**TOWN OF NEWBURGH
PLANNING BOARD
TECHNICAL REVIEW COMMENTS**

PROJECT: DORRMANN SUBDIVISION
PROJECT NO.: 21-03
PROJECT LOCATION: SECTION 1, BLOCK 1, LOT 93
REVIEW DATE: 30 APRIL 2021
MEETING DATE: 6 MAY 2021
PROJECT REPRESENTATIVE: TALCOTT ENGINEERING

Re: Resubmission letter
Town Project No. 2021-03
Dorrmann Subdivision
Weaver Road
SBL: 1-1-93
AR Zone
Job No. 20177-RDR

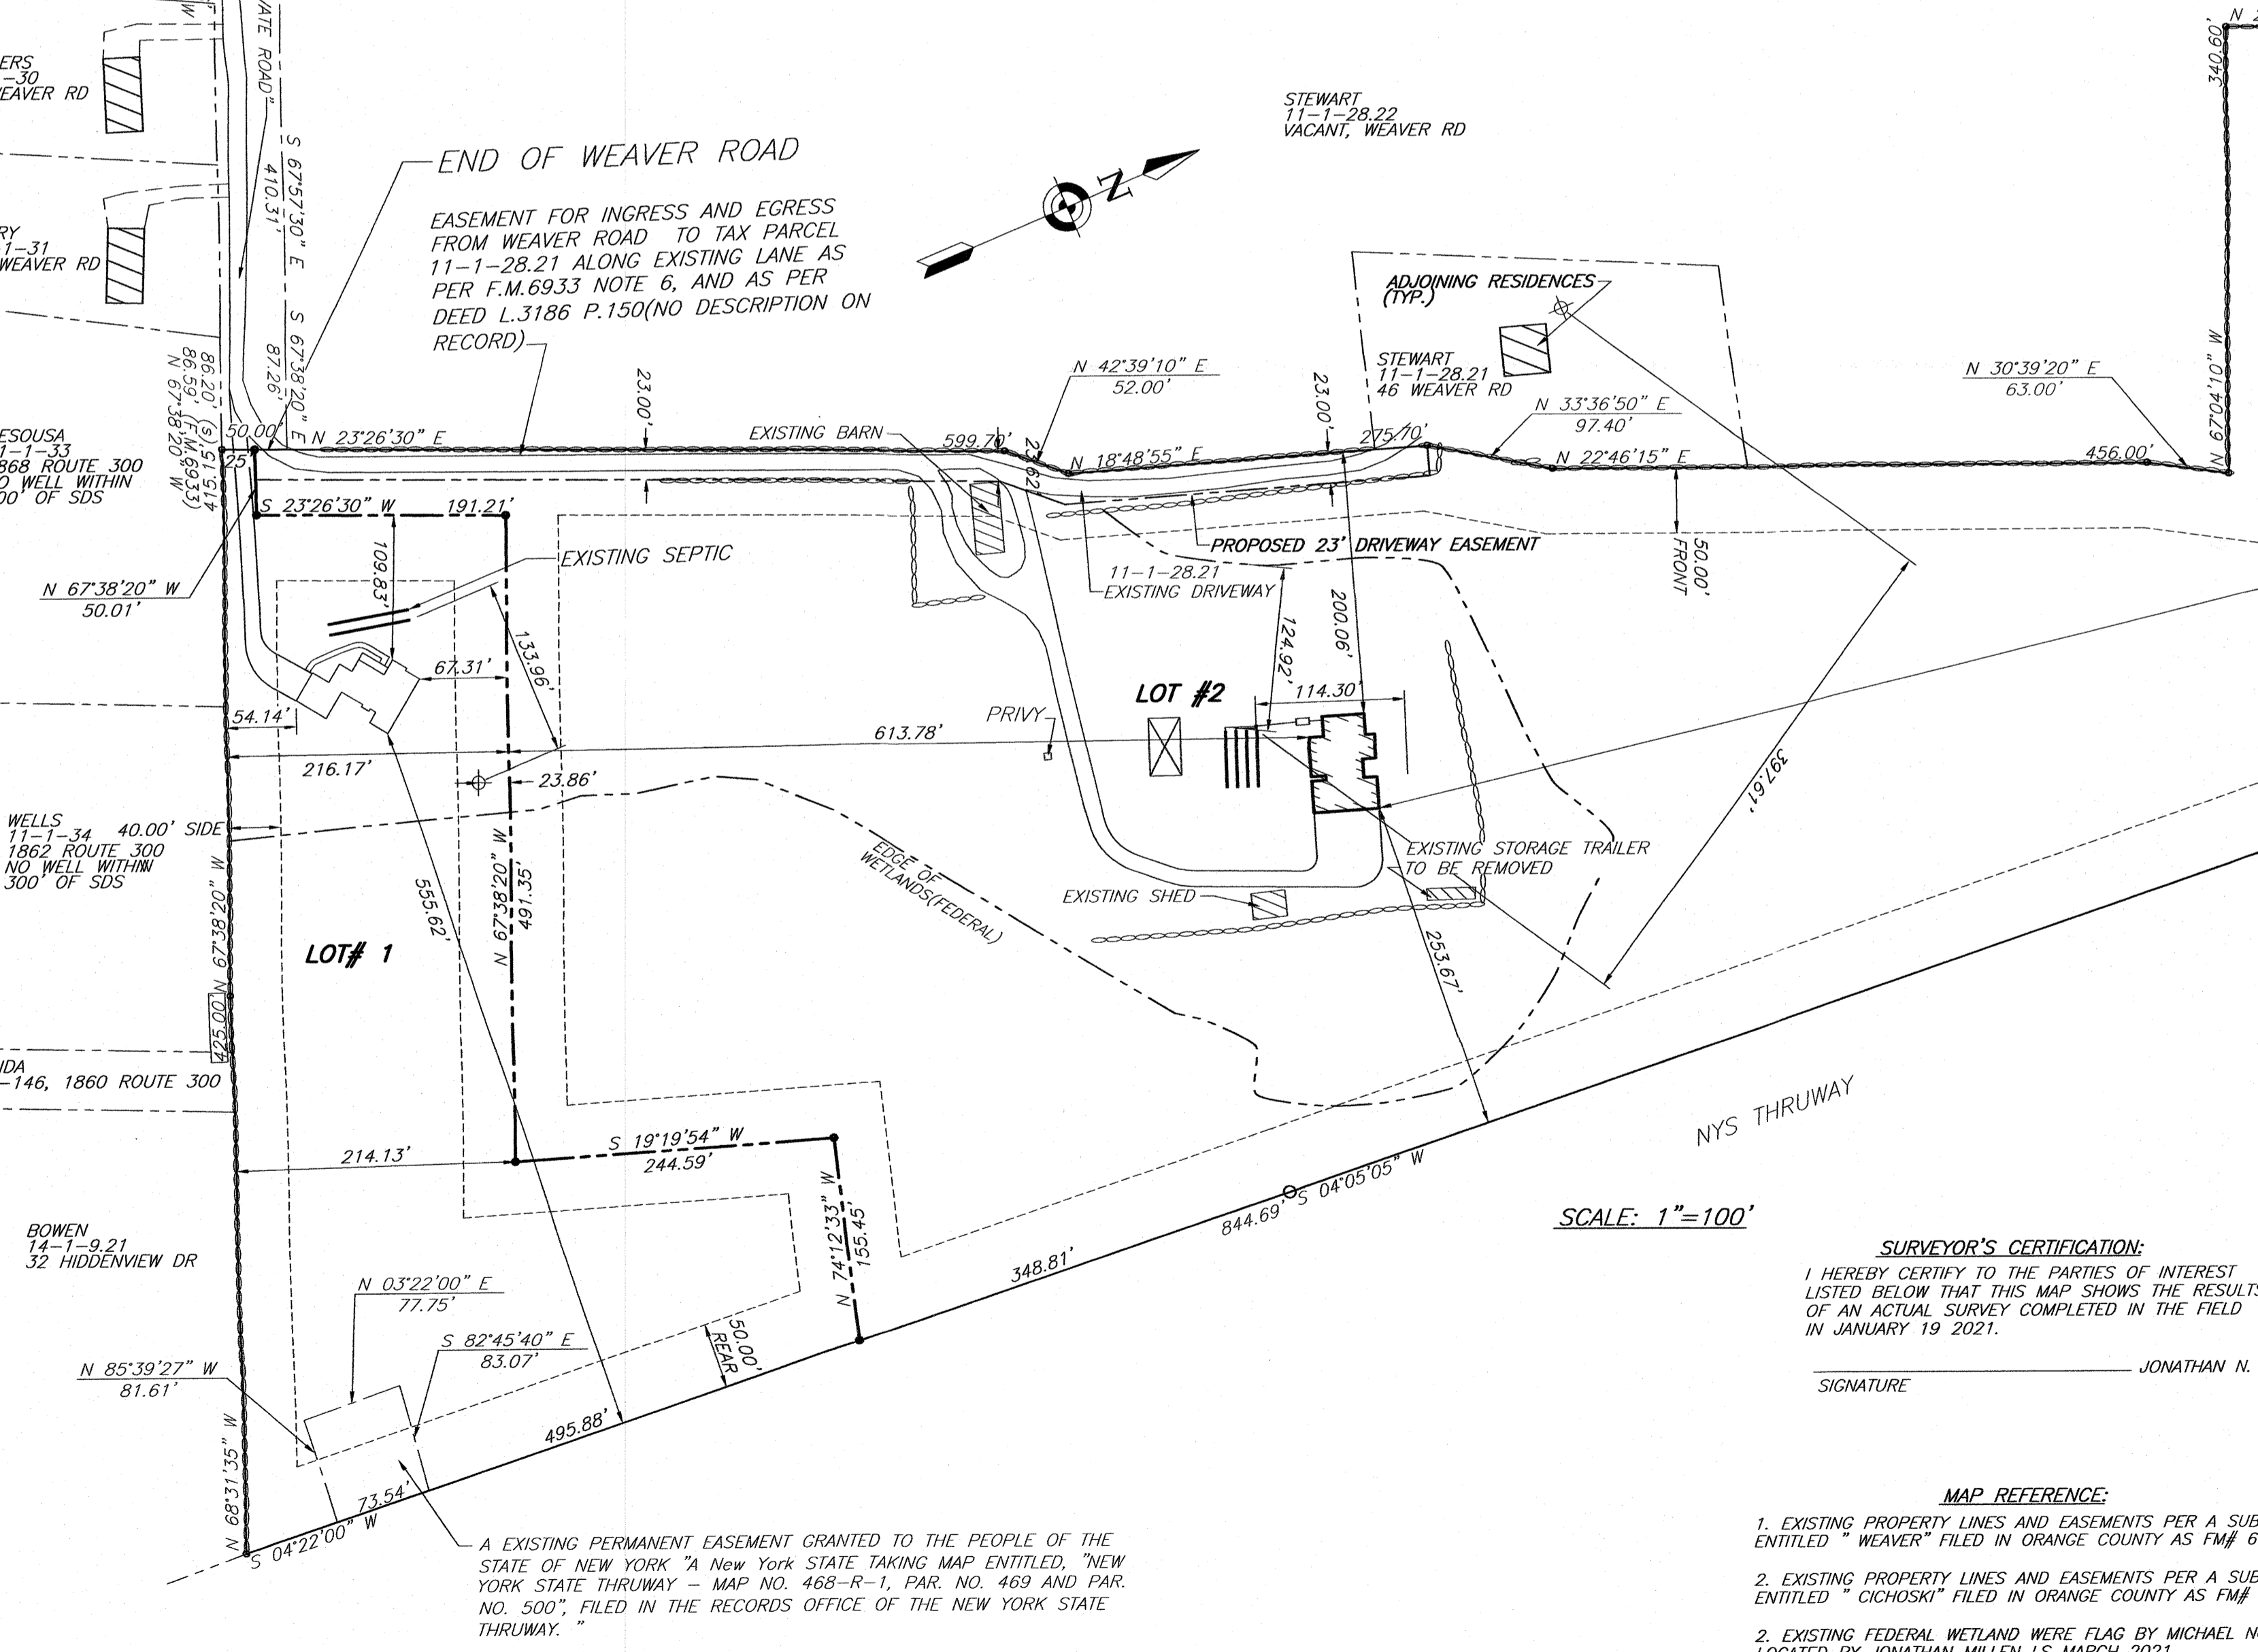
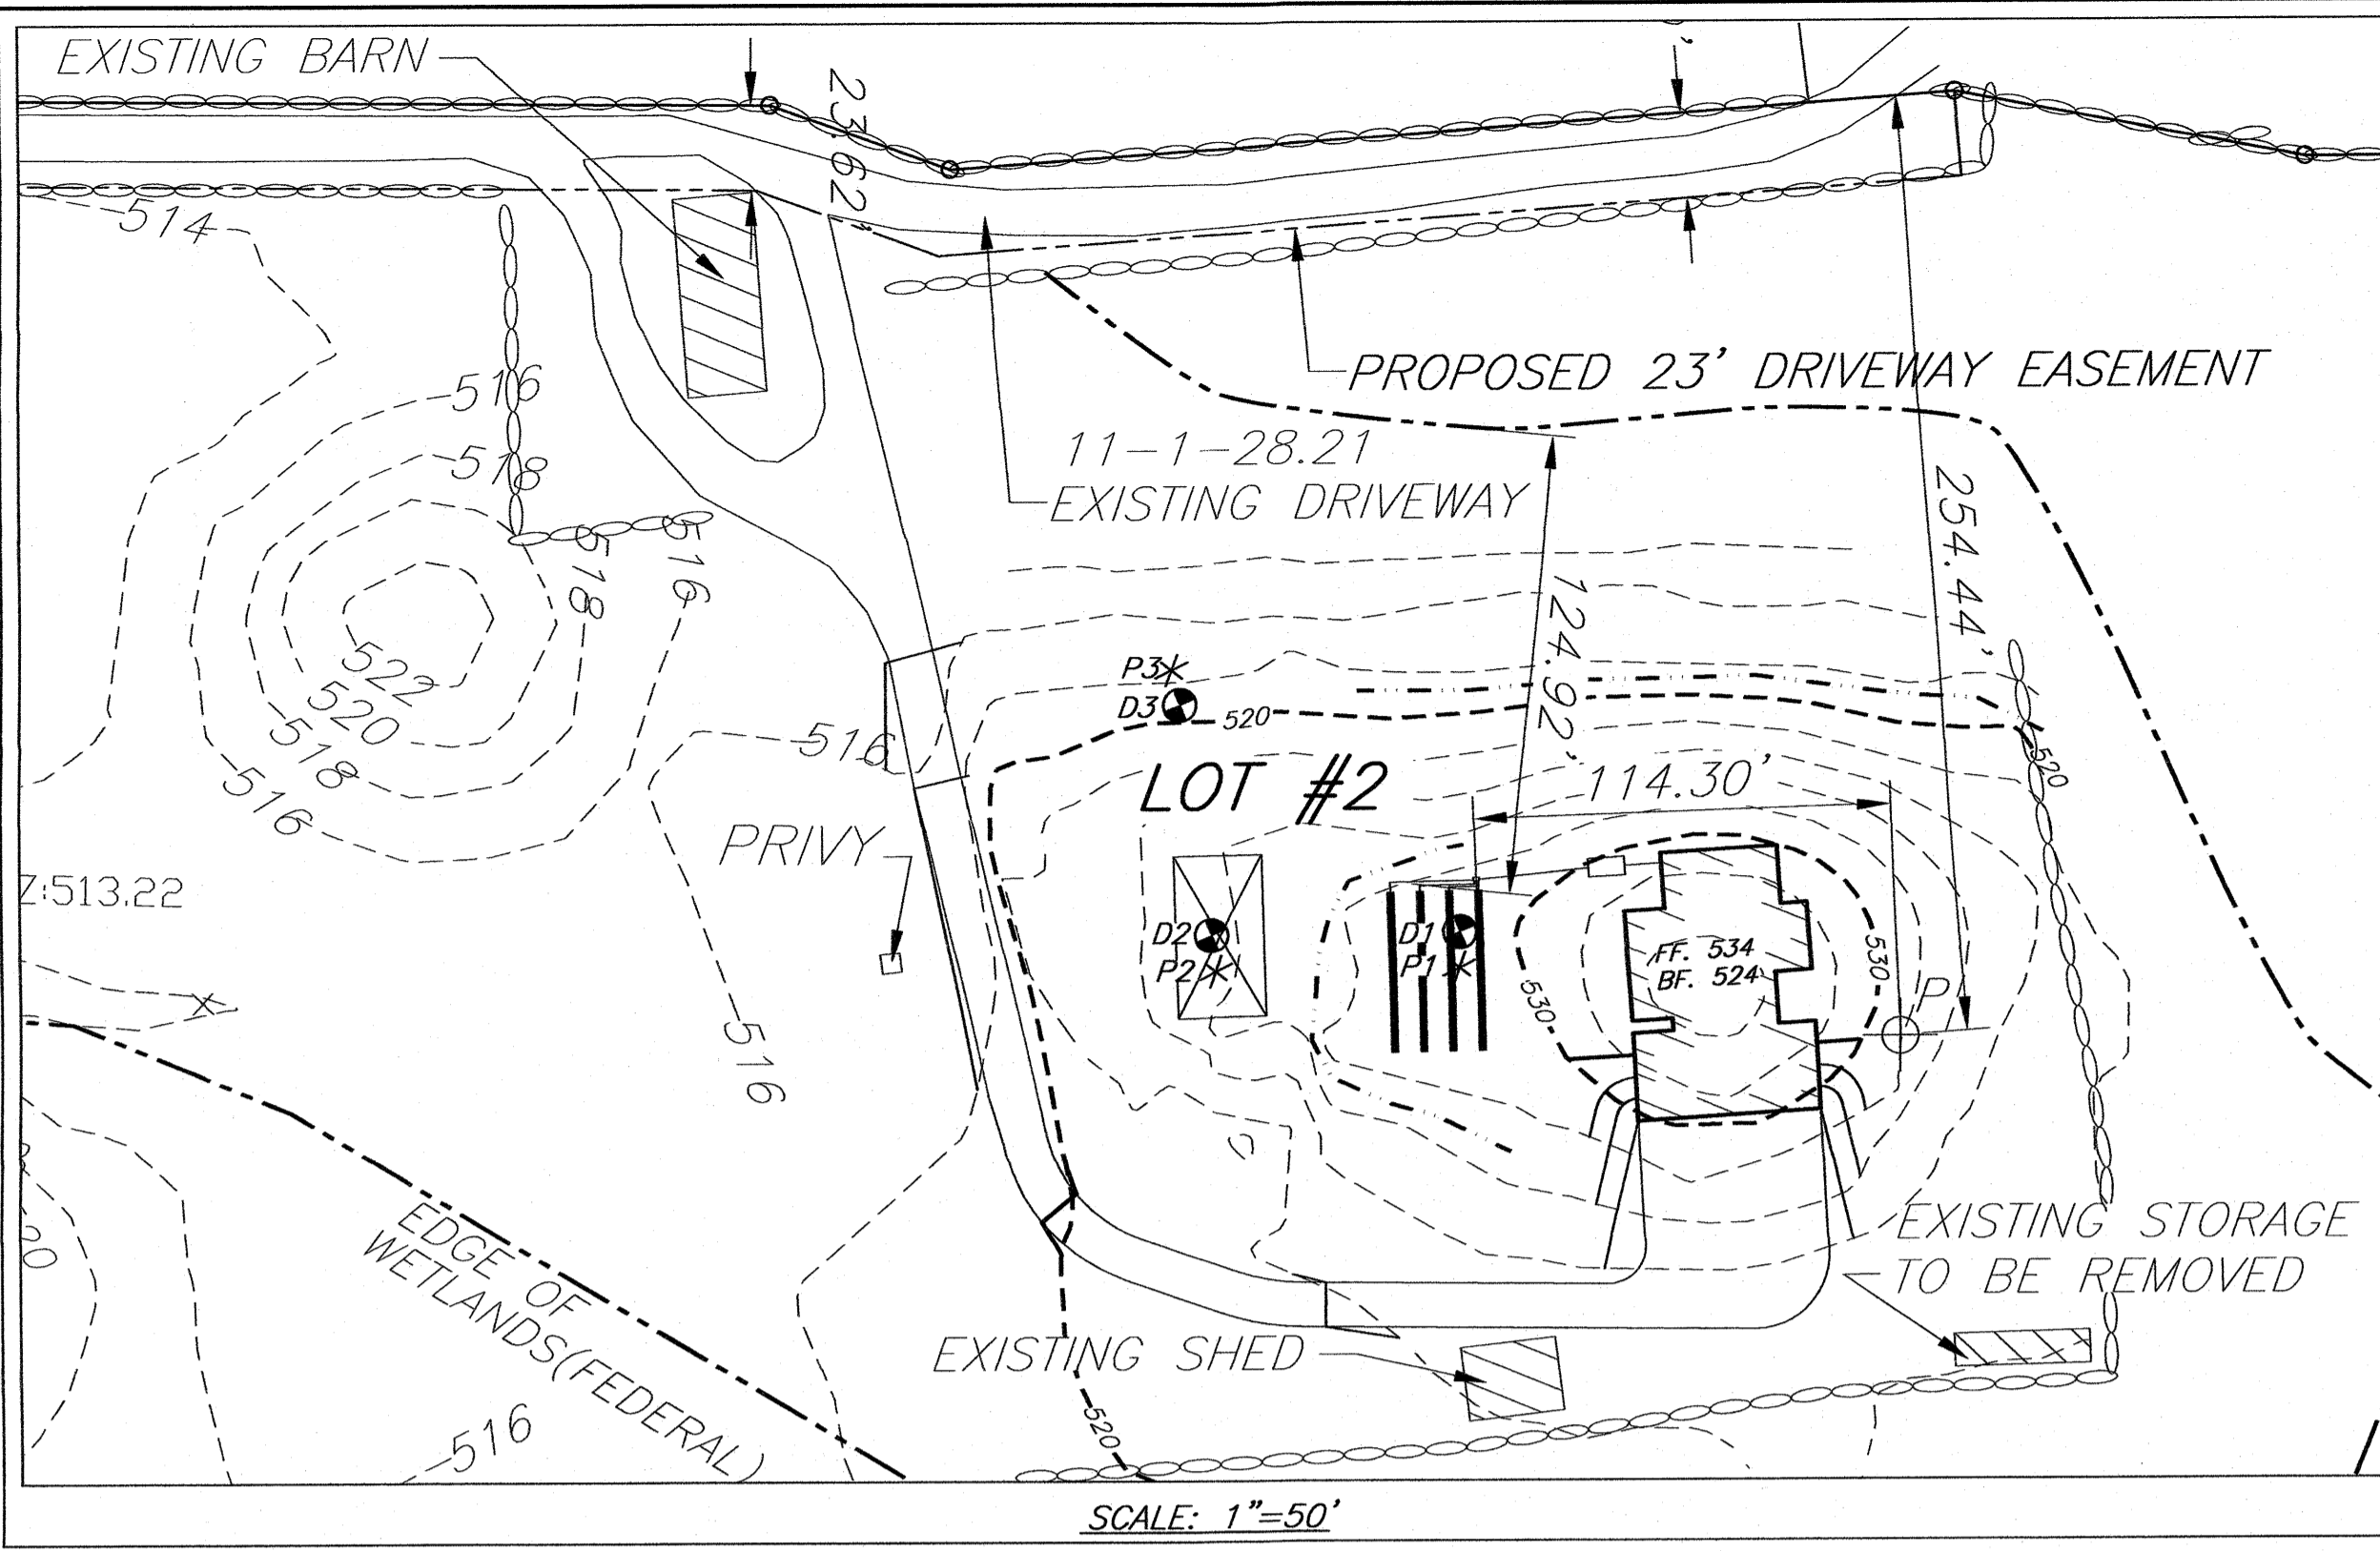
2. The existing storage trailer has been depicted to be removed. This will be a condition of any approvals that the trailer be removed signing of the maps.

3. This well should be depicted on the large scale plan.
4. Information regarding the proposed 23 foot wide driveway easement to the adjoining lots now or formerly Stewart, Tax Lot 28.21, was requested to be submitted to the Planning Board Attorney. The Applicants representative have identified they will address this with the Planning Board at the meeting.

5. The Applicants are requesting a waiver of topography on the balance of parcel. Topography has been depicted on an Inset Map 50 scale on the plan.
6. Orange County Planning has reviewed the project and had no comments. A local determination has been issued.

- 1) Surveyor will provide by Planning Board Meeting
- 2) 25' frontage is labeled for Lot 1.
- 3) Storage trailer is noted "to be removed."
- 4) Wells and septic are shown as requested.
- 5) Wetland is now delineated and surveyed.
- 6) I will address at the Planning Board Meeting.
- 7) A waiver on topography is requested.
- 8) (No response required)
- 9) (No response required)
